Economic Commission for Europe**Inland Transport Committee****World Forum for Harmonization of Vehicle Regulations****Working Party on Noise and Tyres****Seventieth session**

Tyres: UN Regulation No. 117 (Tyre rolling resistance, rolling noise and wet grip)**Proposal for an amendment to complement the content of working document ECE/TRANS/WP.29/GRVA/2018/5****Submitted by the experts from the European Tyre and Rim Technical Organisation***

The text reproduced below was prepared by the experts from the European Tyre and Rim Technical Organisation (ETRTO) to amend UN Regulation No. 117. The modifications to the existing text of the Regulation are marked in bold for new or strikethrough for deleted characters.

Annex 2, Appendix 2, example 2, figure, amend to read:

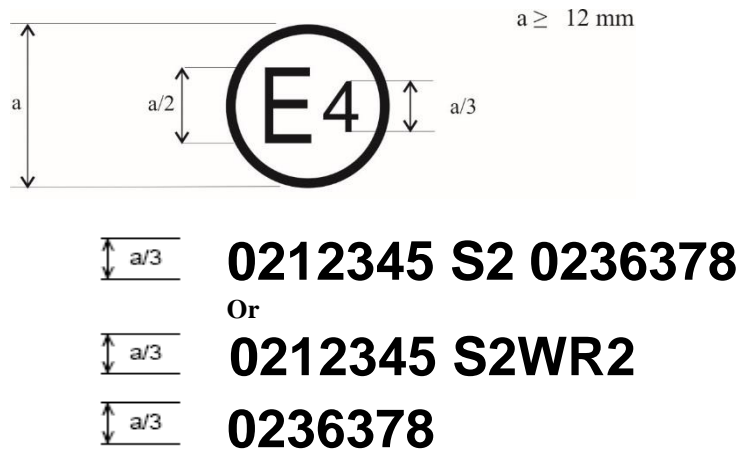
11. The figure in Annex 2, Appendix 2 was unintentionally changed during one of the previous amendments of UN Regulation No. 117. It is proposed to restore the figure in its original form.
